Signature:		
Company:		
ADDENDU	M NO. 1	DATE: MAY 15, 2024
RE: CIT	Y OF CORNING, ARKANSAS – CONSTRUCT HELIF	PAD – 24-5724
FROM:	McClelland Consulting Engineers, Inc. 7302 Kanis Road Little Rock, Arkansas 72204 Phone: 501/371-0272

This Addendum forms a part of the Contract Documents and modifies the original Bidding Documents dated **May 3**, **2024** as noted below. Acknowledge receipt of the Addendum in the space provided on the Bid Form. Failure to do so may subject the Bidder to disqualification.

1. Sheet 12 - MISCELLANEOUS DETAILS III.

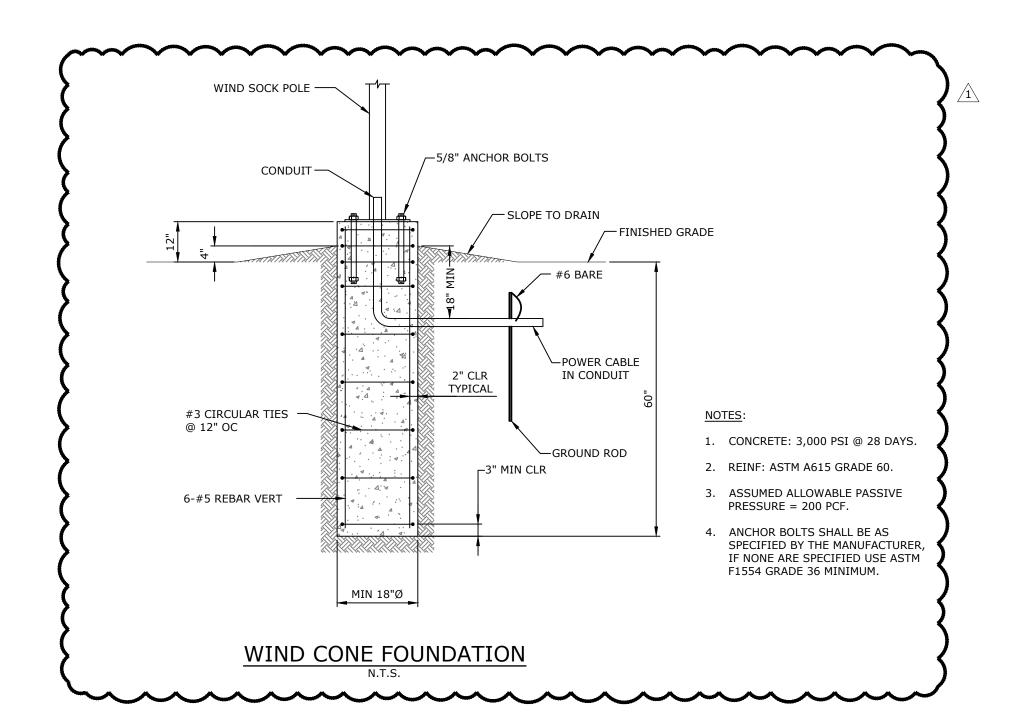
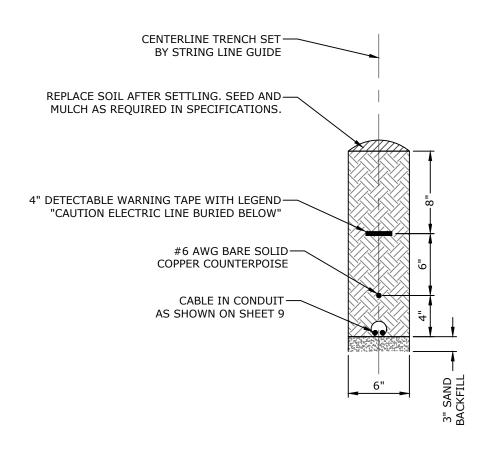
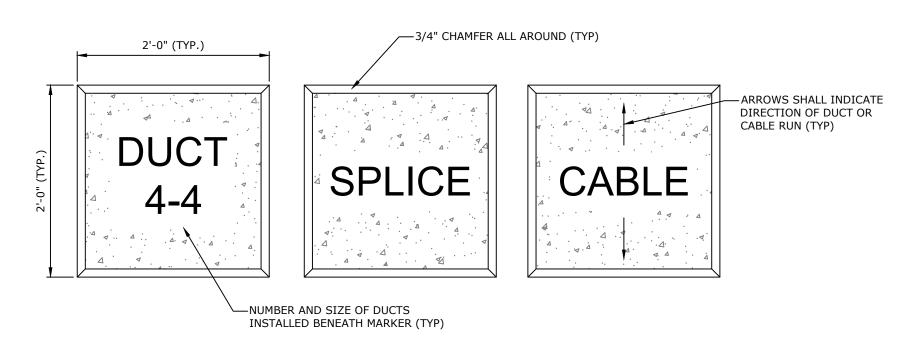
Replace Sheet 12 MISCELLANEOUS DETAILS III with attached revised Sheet 12 MISCELLANEOUS DETAILS. Sheet includes updated wind cone foundation detail to no longer include box and L-830 transformer.
